SUBJECT: PLANS AND PROPOSAL ADDENDUMS
PROJECT: STP 2023 (675)MM CONTROL: 1433-02-044
COUNTY: COMAL
LETTING: 05/04/2023
REFERENCE NO: 0419

PROPOSAL ADDENDUMS

DESCRIPTION OF ABOVE CHANGES
(INCLUDING PLANS SHEET CHANGES)

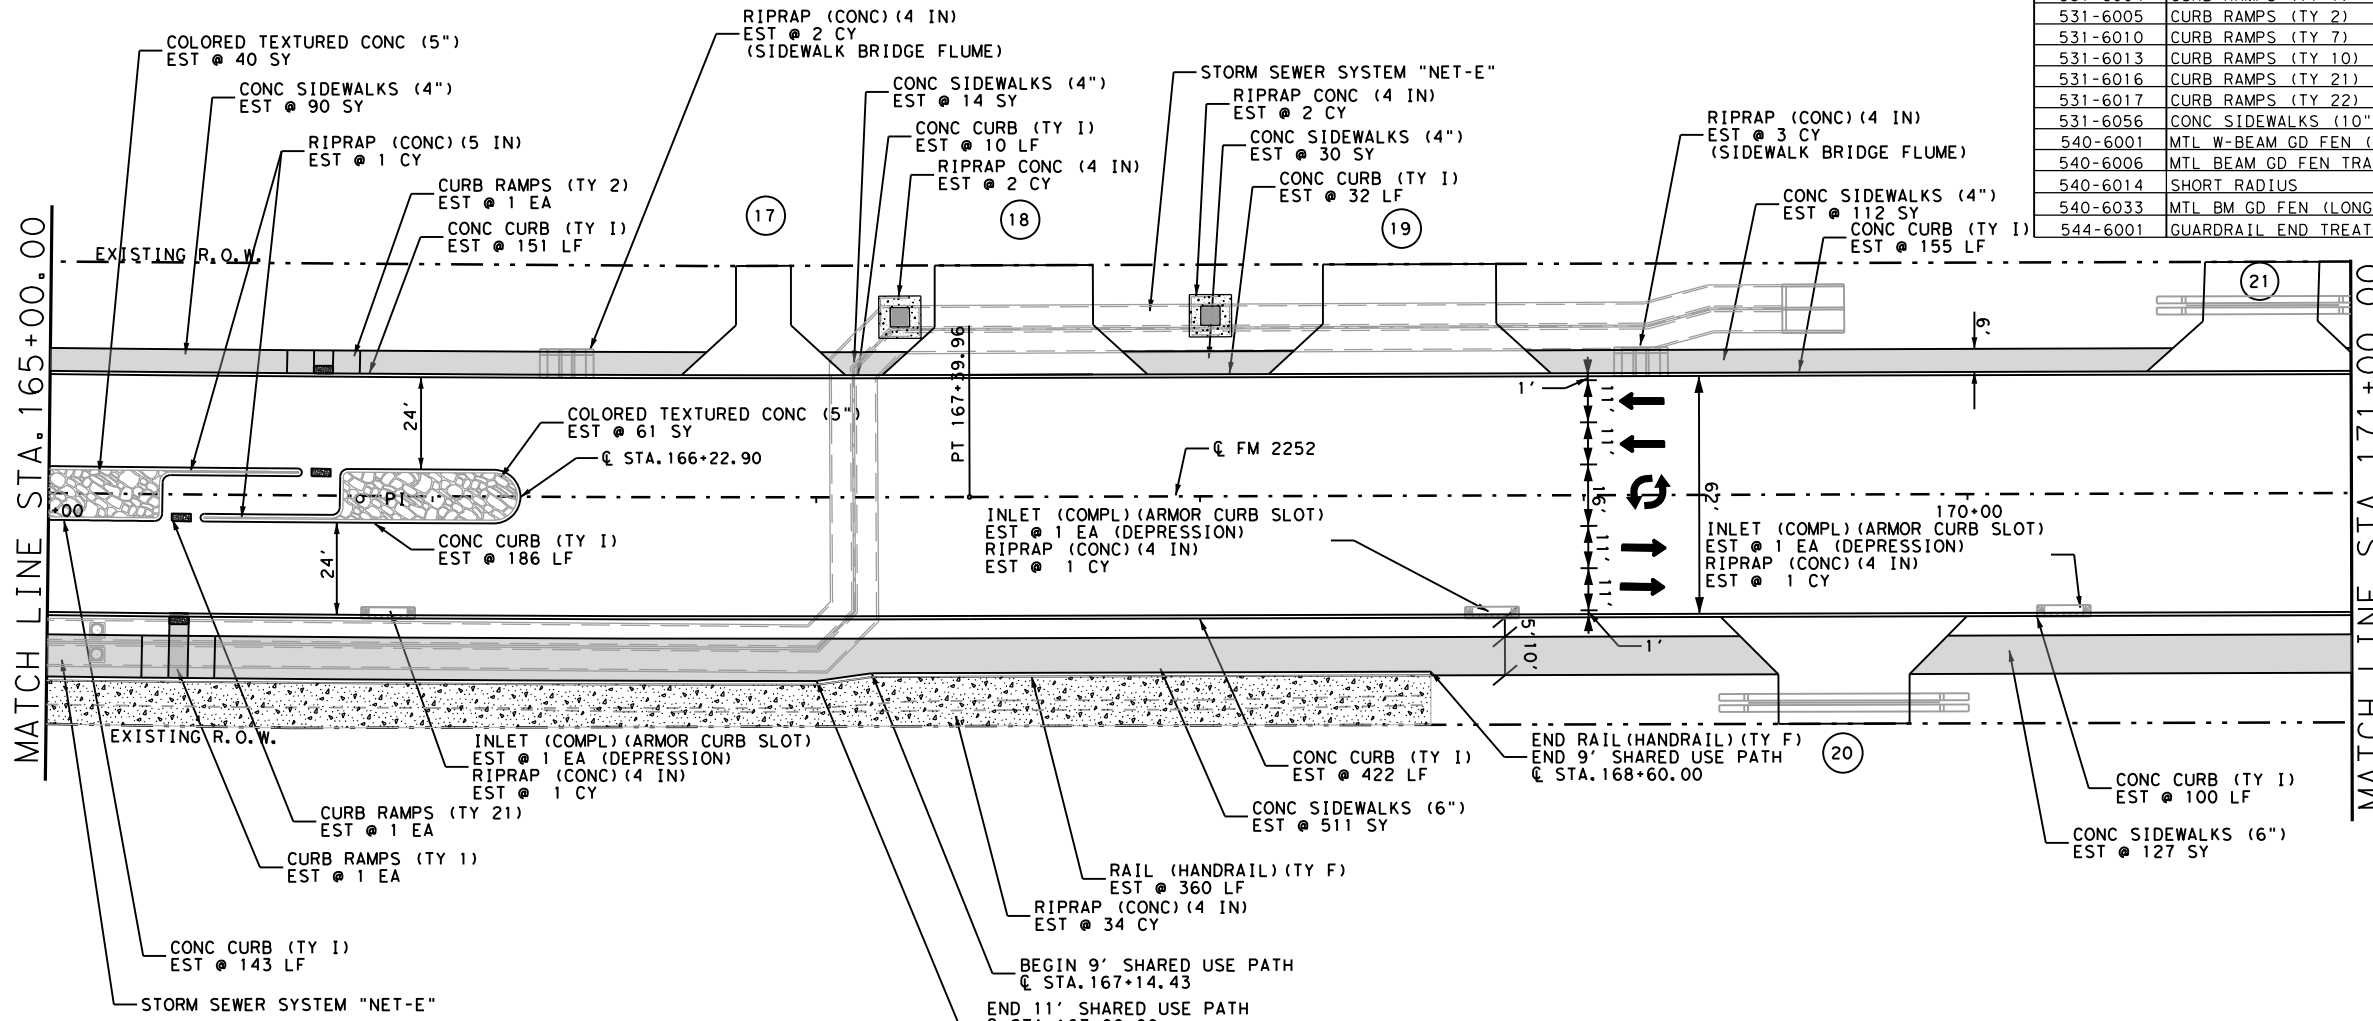
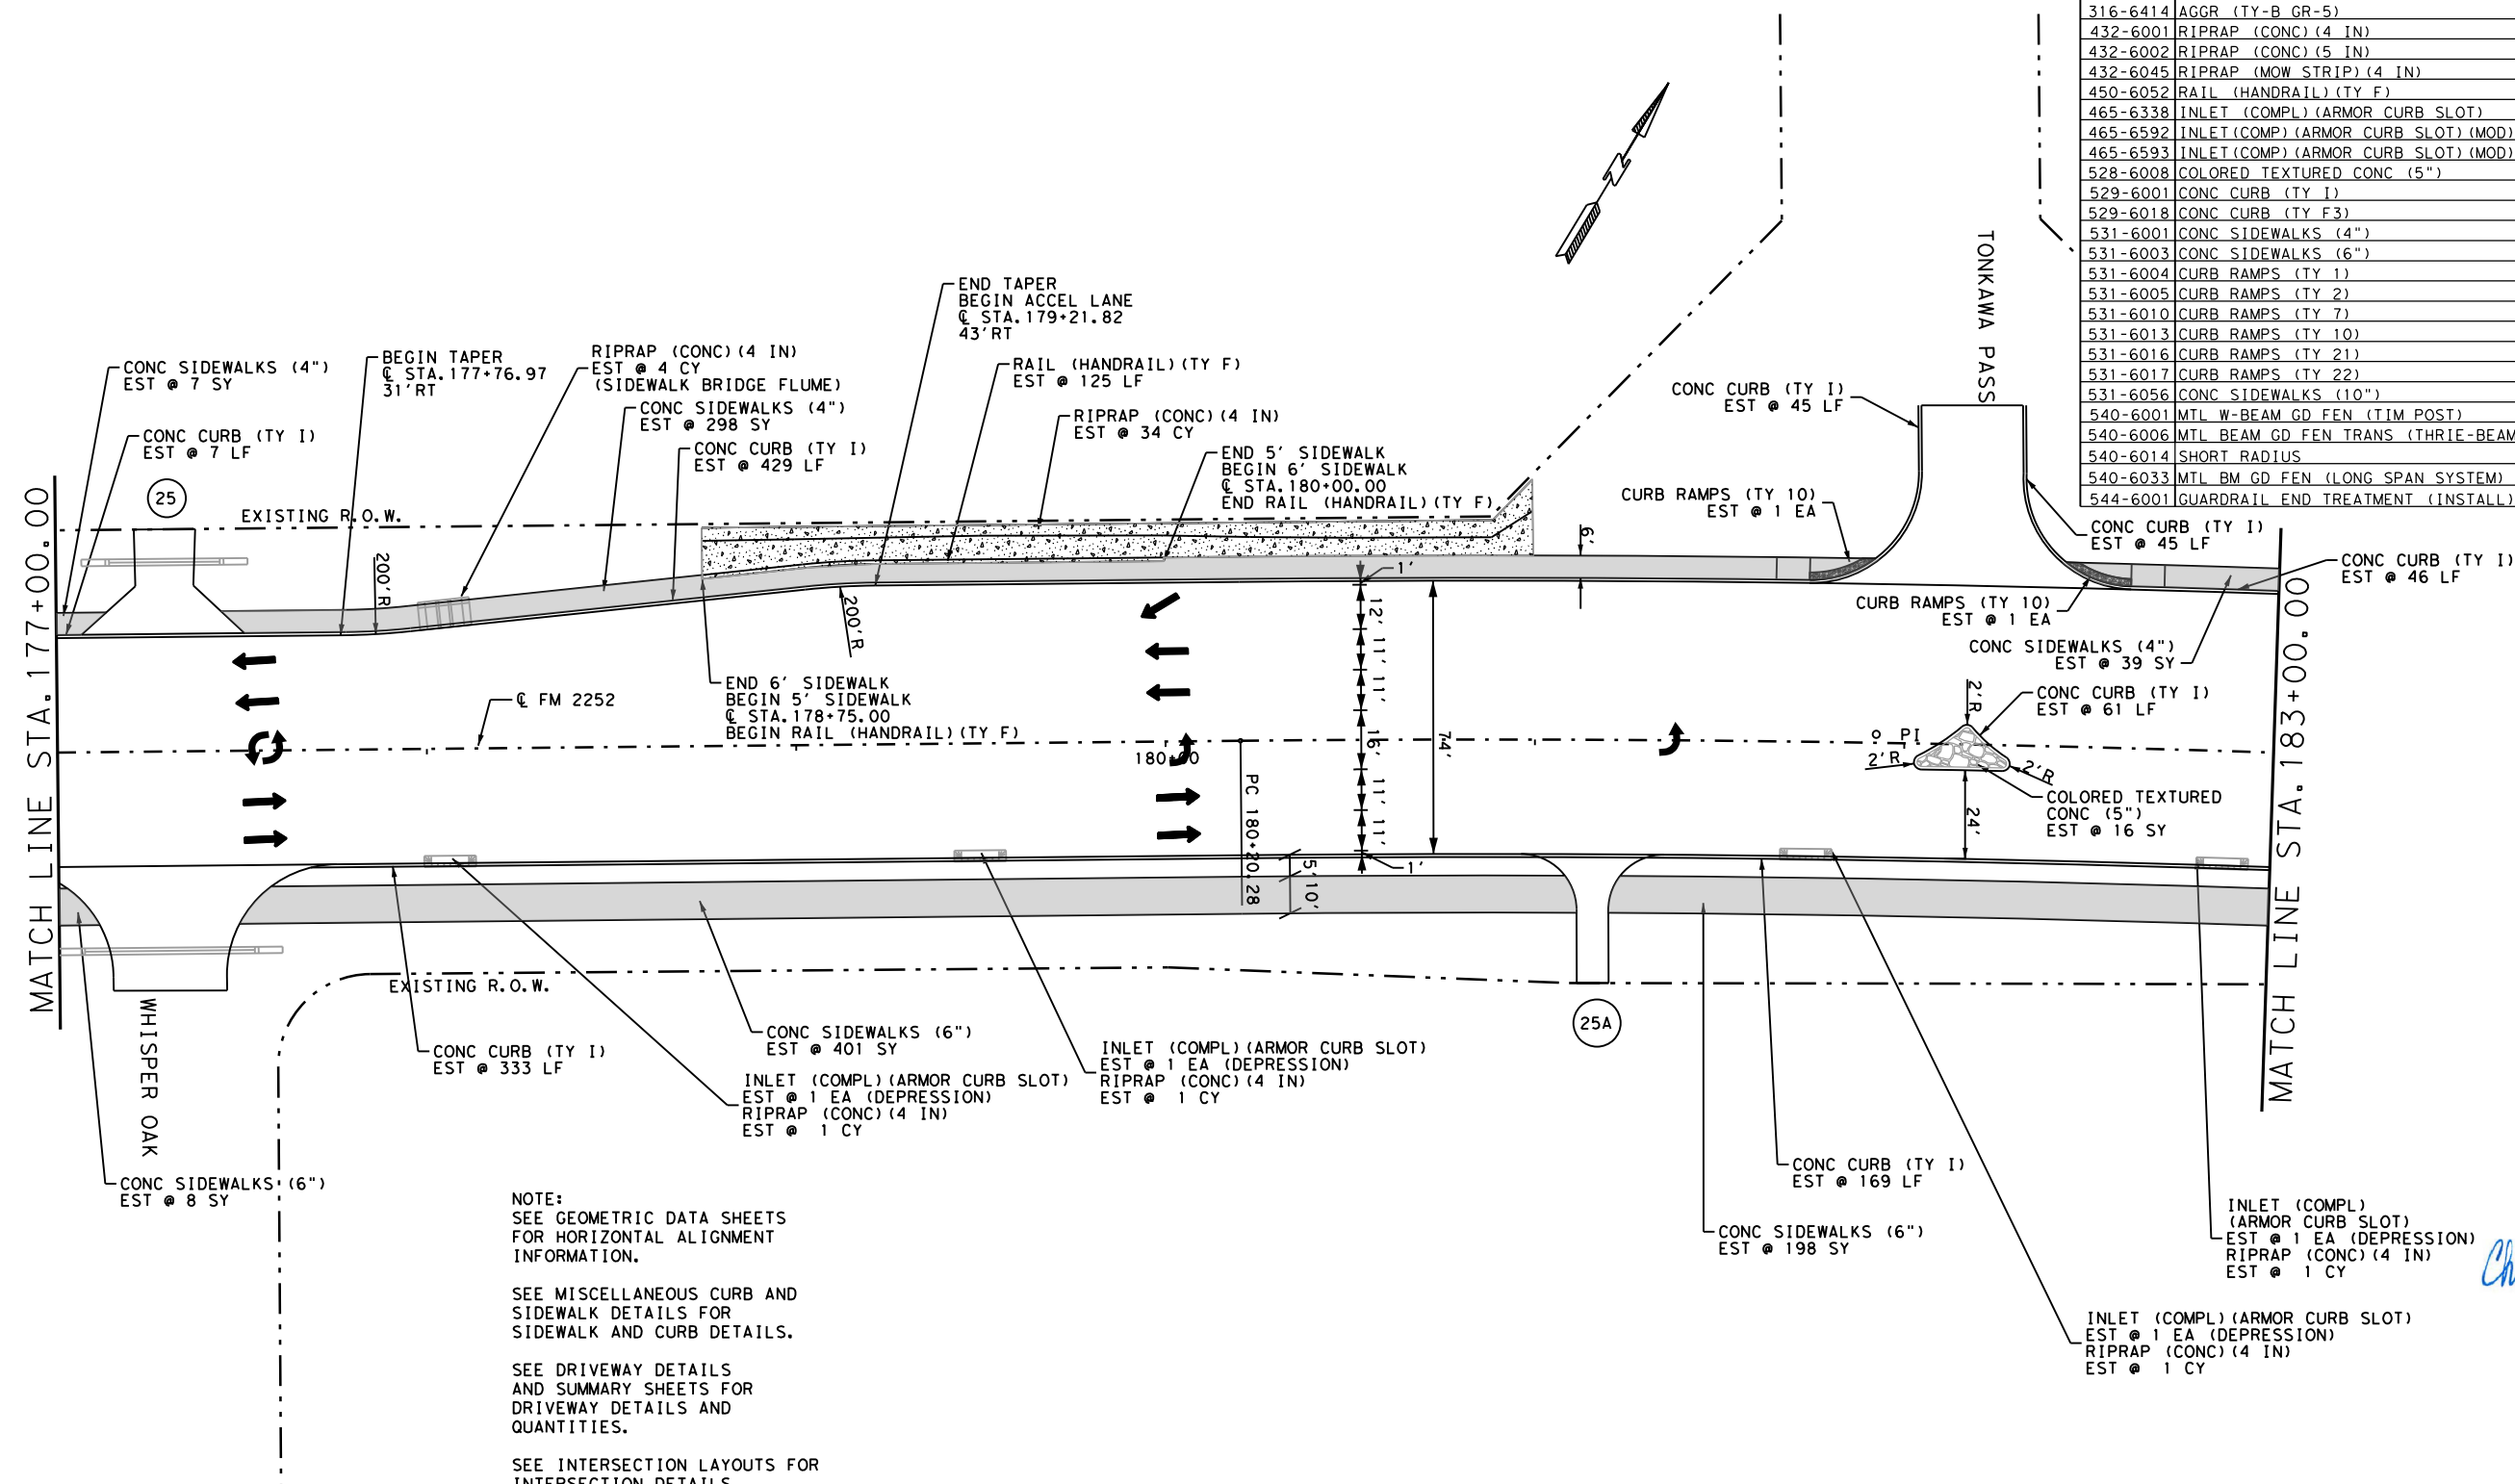
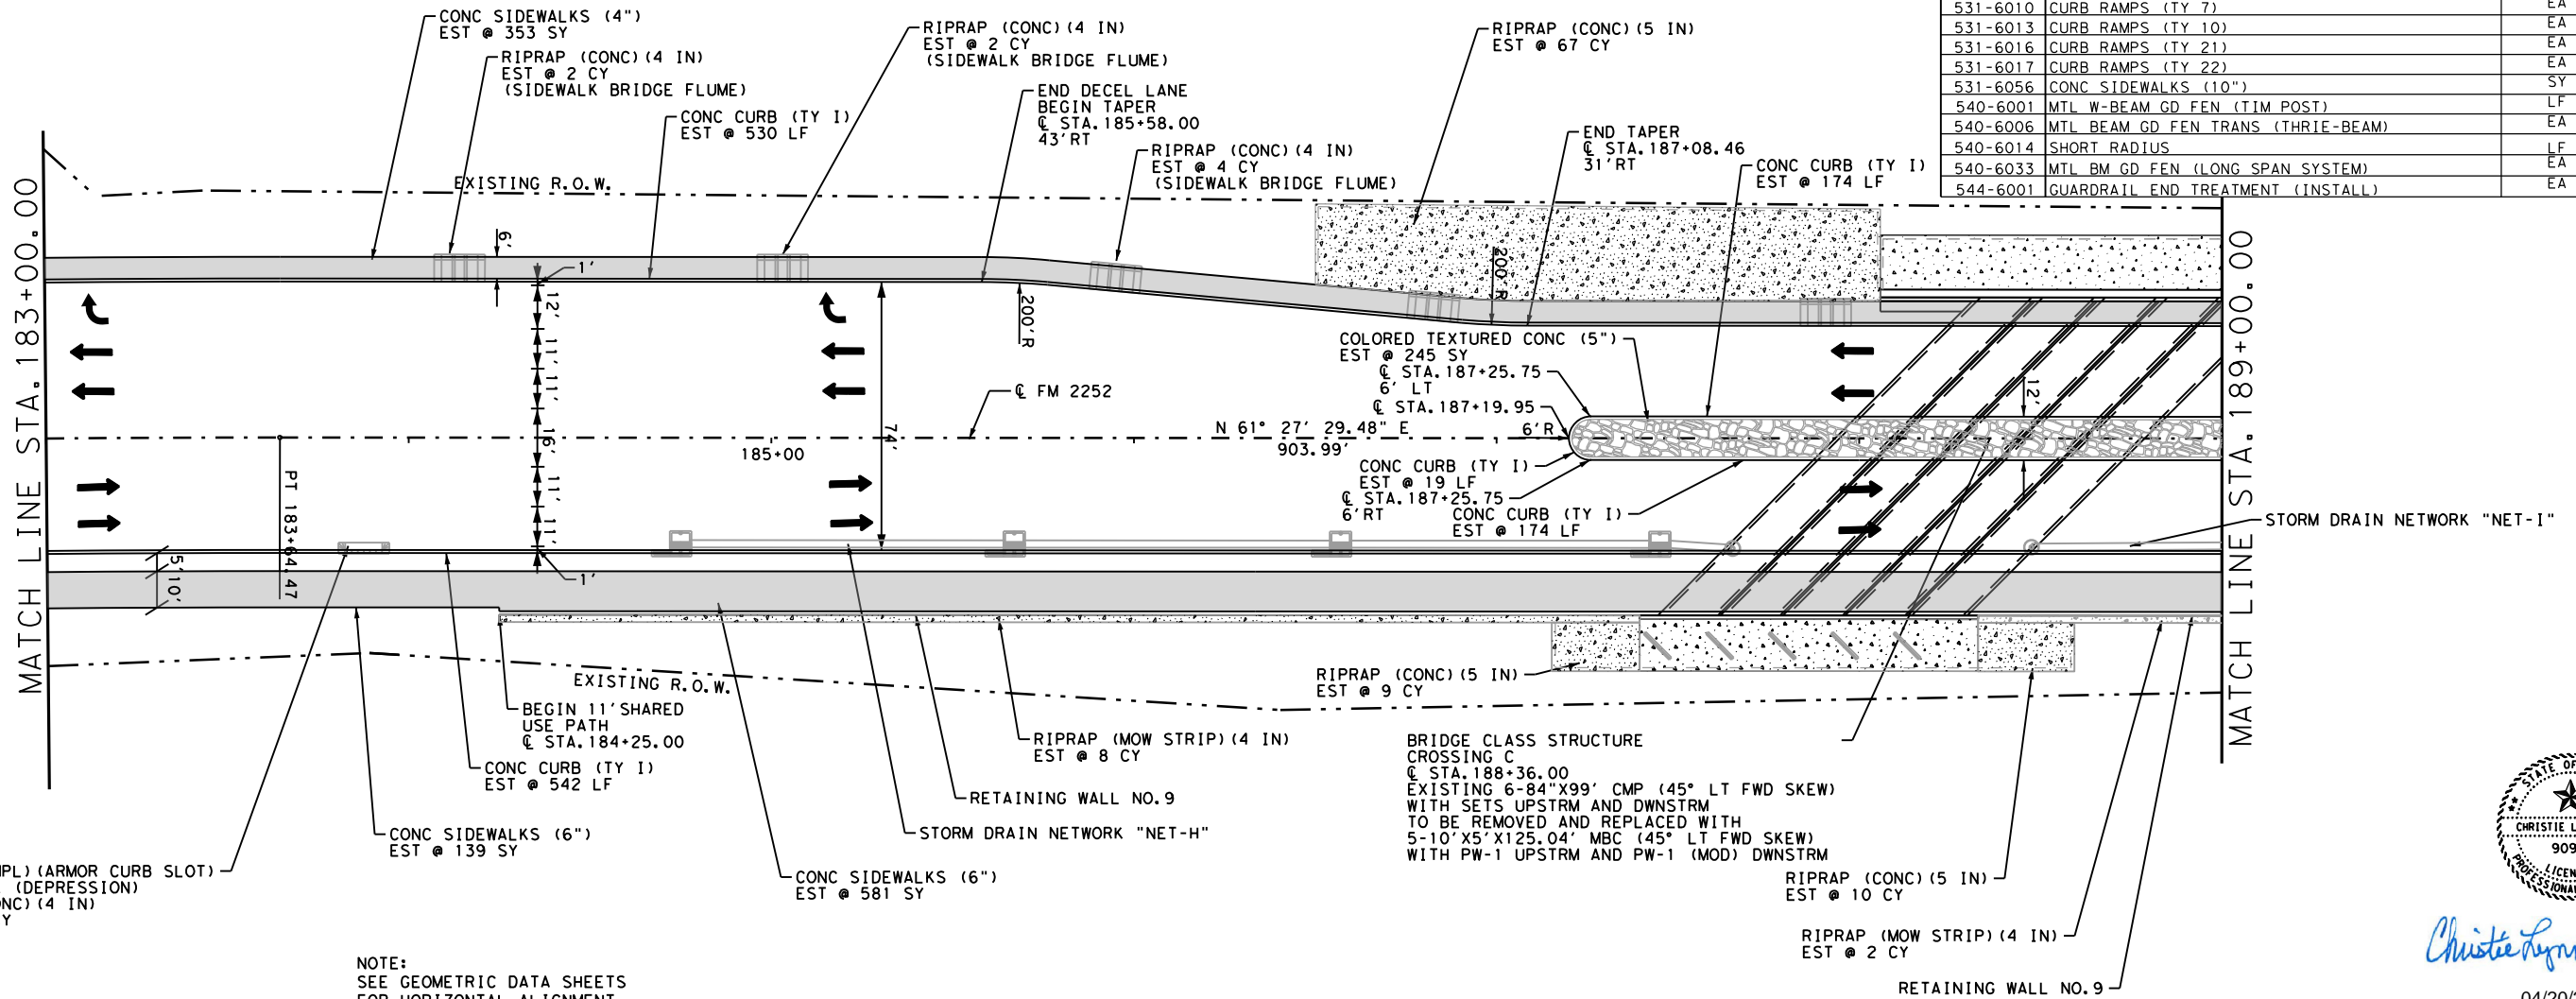
SHEETS 413-449: REPLACED ITEM NO. 545-6017 WITH ITEM NO. 545-6007
